*Lab*  
NRL Report No. R-2225  
BuShips Prob. S347T-C  
(X-108C)

Report on  
TESTS OF MODEL SC-2 RADAR EQUIPMENT

Contractor:  
General Electric Company  
NAVAL RESEARCH LABORATORY  
ANACOSTIA STATION  
WASHINGTON, D. C.

FRONT OBLIQUE OF SC-2 ANTENNA  
 PROJECTION ANGLE 30°  
 SHORTENING 0.966:1:1

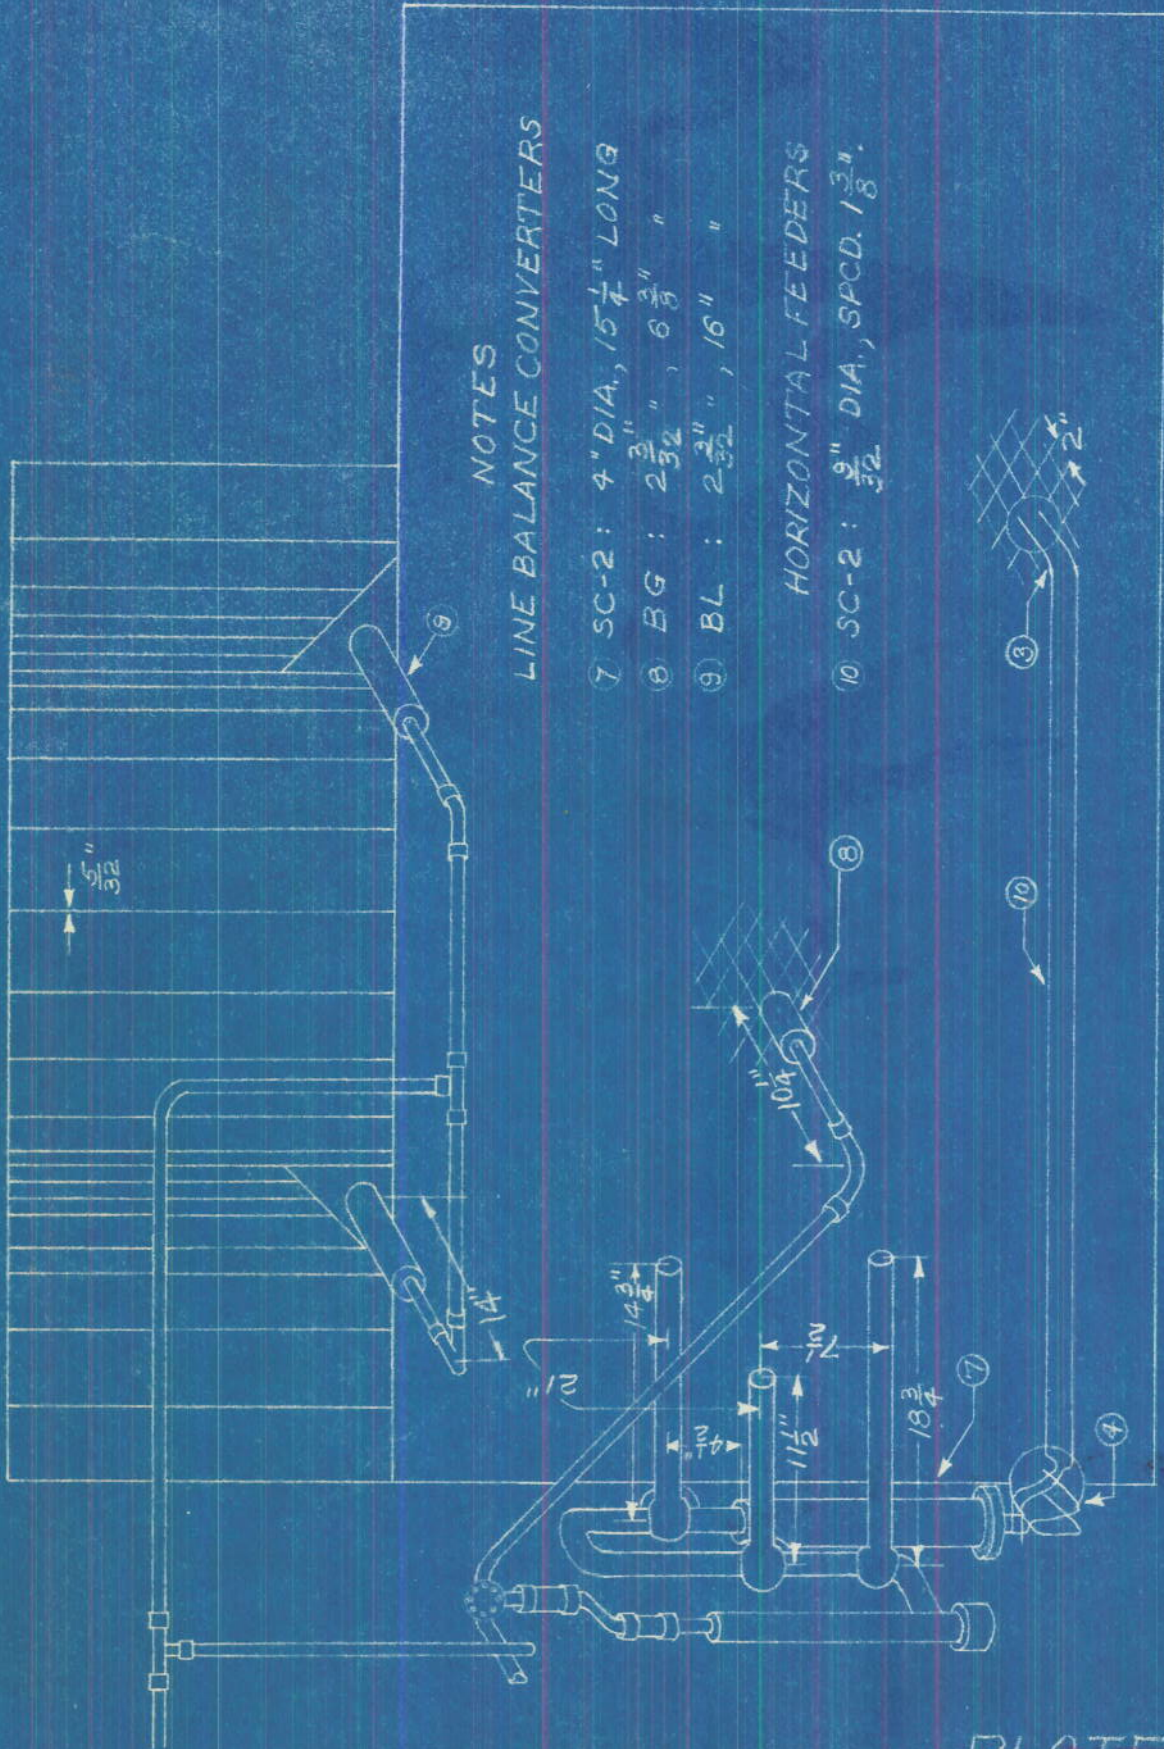
0-6-2. The transmitter suffered only slight damage when subjected to vibration. The antenna, however, was severely damaged by vibration and must be strengthened or otherwise modified before satisfactory service can be expected.

0-8-6. (2-4-2a, 2-4-2b) When the antenna was subjected to vibration, various parts oscillated excessively as a result of mechanical resonance. Breakage occurred at several points as a result of vibration. It is recommended that the antenna be so modified to prevent these failures. It was not determined whether the large displacements resulting from the mechanical resonance will change the antenna pattern sufficiently to interfere with the operation of the equipment.

PLATE 9 SEC. 1

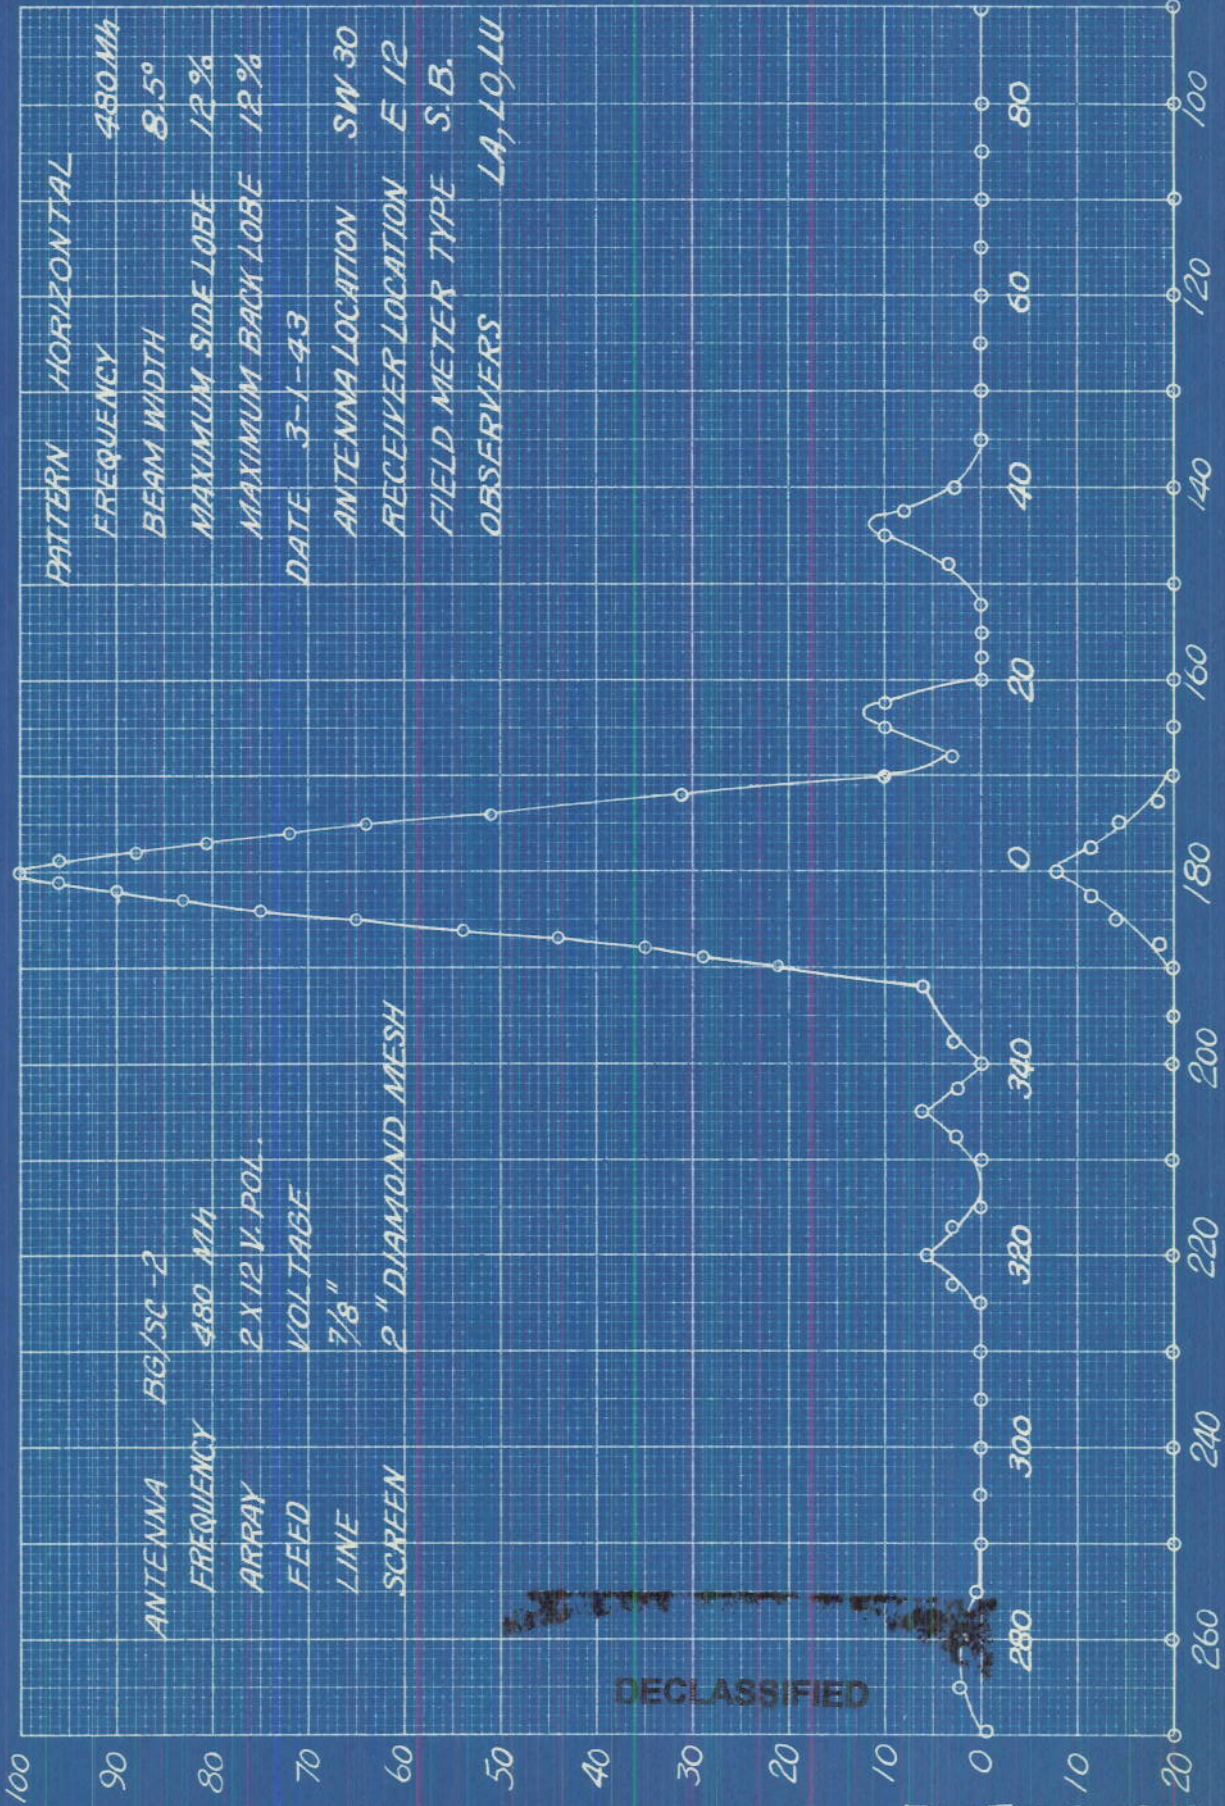
1-17-4. ELECTRICAL TESTS OF BG ANTENNA. Plate 9 of Section I is a pattern, taken at 480 mc., of the BG recognition array. The beam width is  $8.5^{\circ}$ . Side lobes at  $16^{\circ}$  and  $38^{\circ}$  show amplitudes of 12% on the right side and 6% on the left side of the forward direction. A 12% lobe appears directly backwards. Some rather sketchy measurements (Plate 10) show that the BG is well matched over its entire band, 460 to 500 mc.

PLATE II SEC.

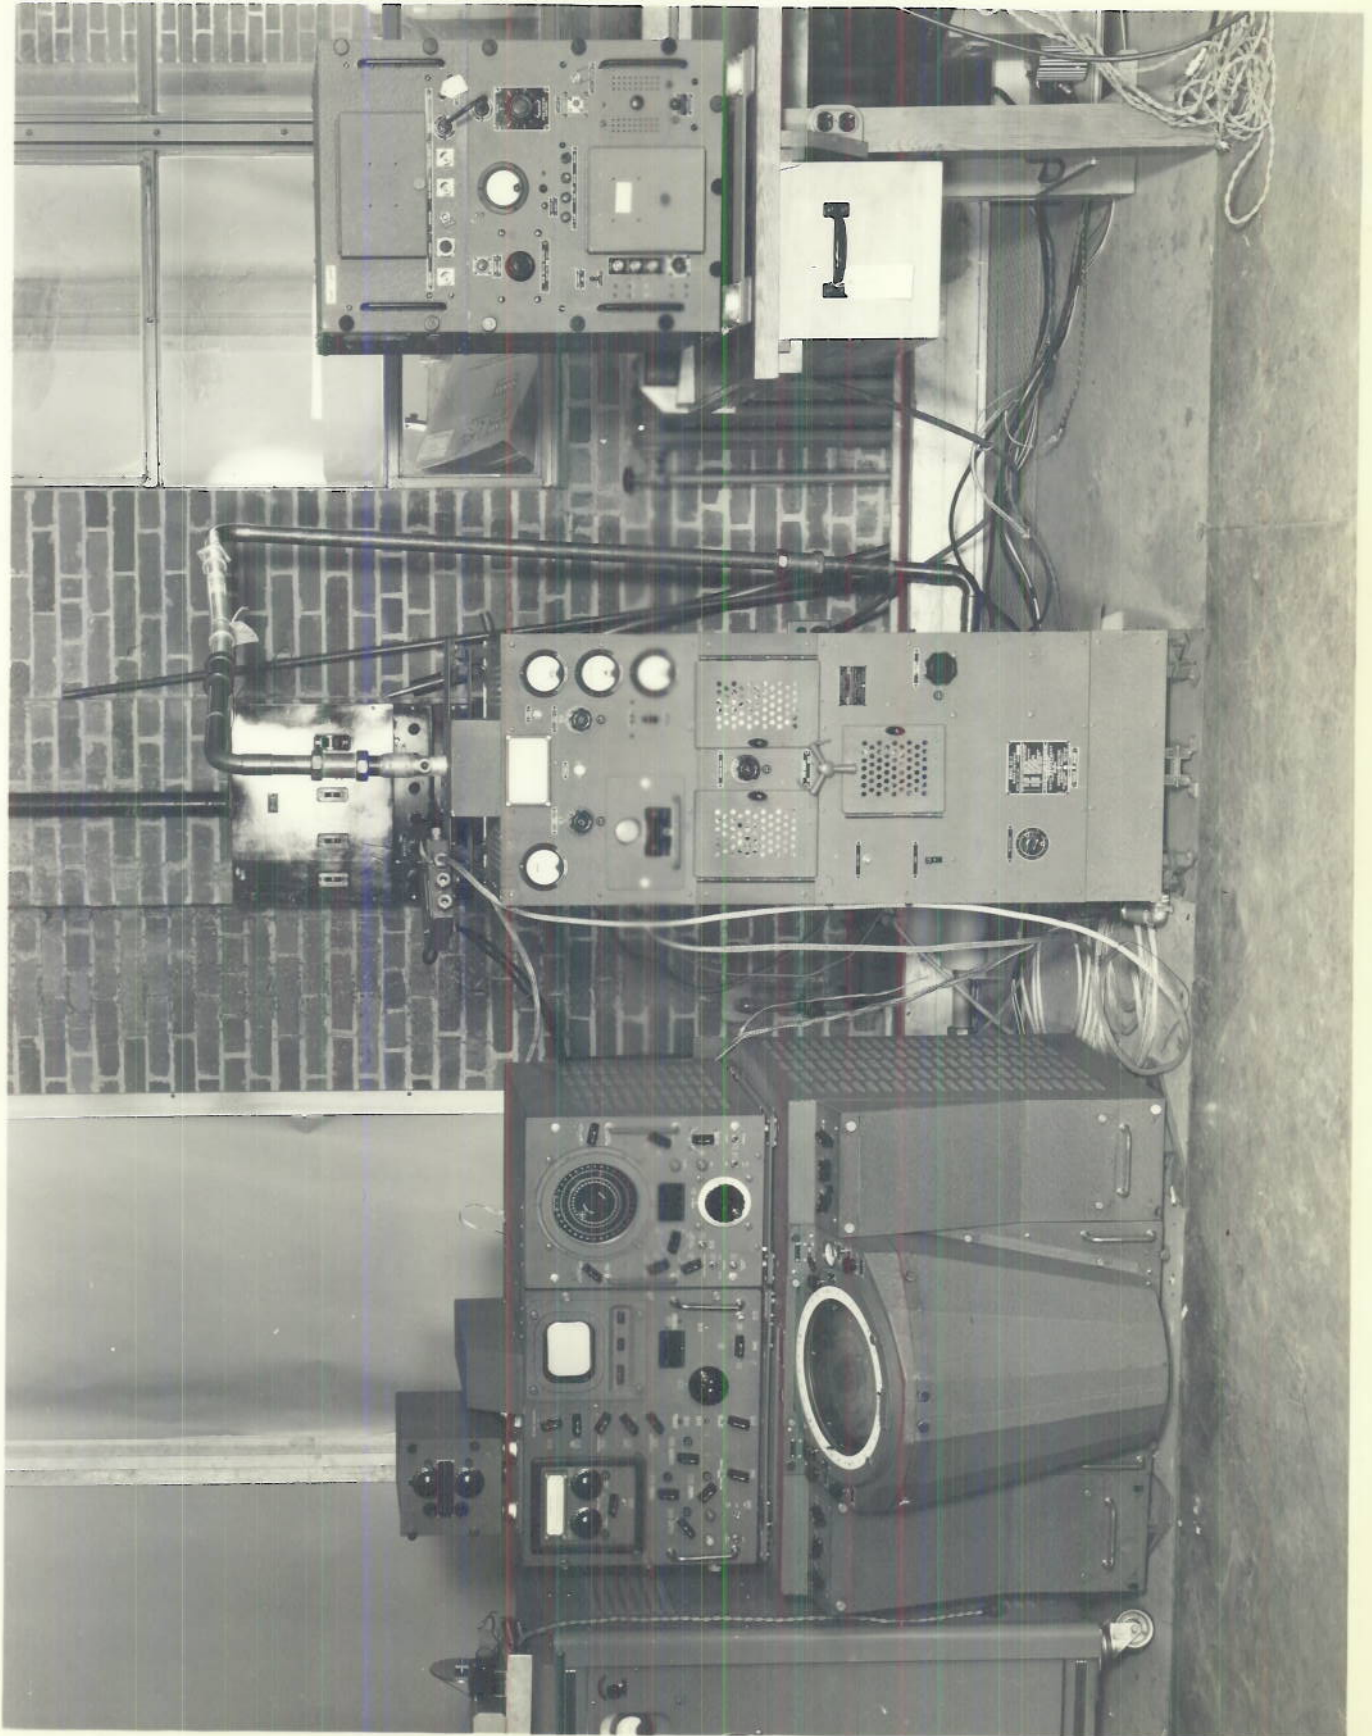
1-17-5. ROUGH ANTENNA PATTERN. During the operational tests, rough antenna patterns were made with the Annapolis Radio Towers and with Sharps Island Light as the targets. Plate 11 of Section I shows the curves which were obtained when relative echo heights were plotted against bearing readings. At the half-maximum points the beam-width was  $18.5^{\circ}$  for the Annapolis Towers and  $20^{\circ}$  for Sharps Island Light. As noted in paragraph 1-8, a plane flying at 1,000 feet altitude was followed in to 6,200 yards. This corresponds to an elevation angle of  $32^{\circ}$ .
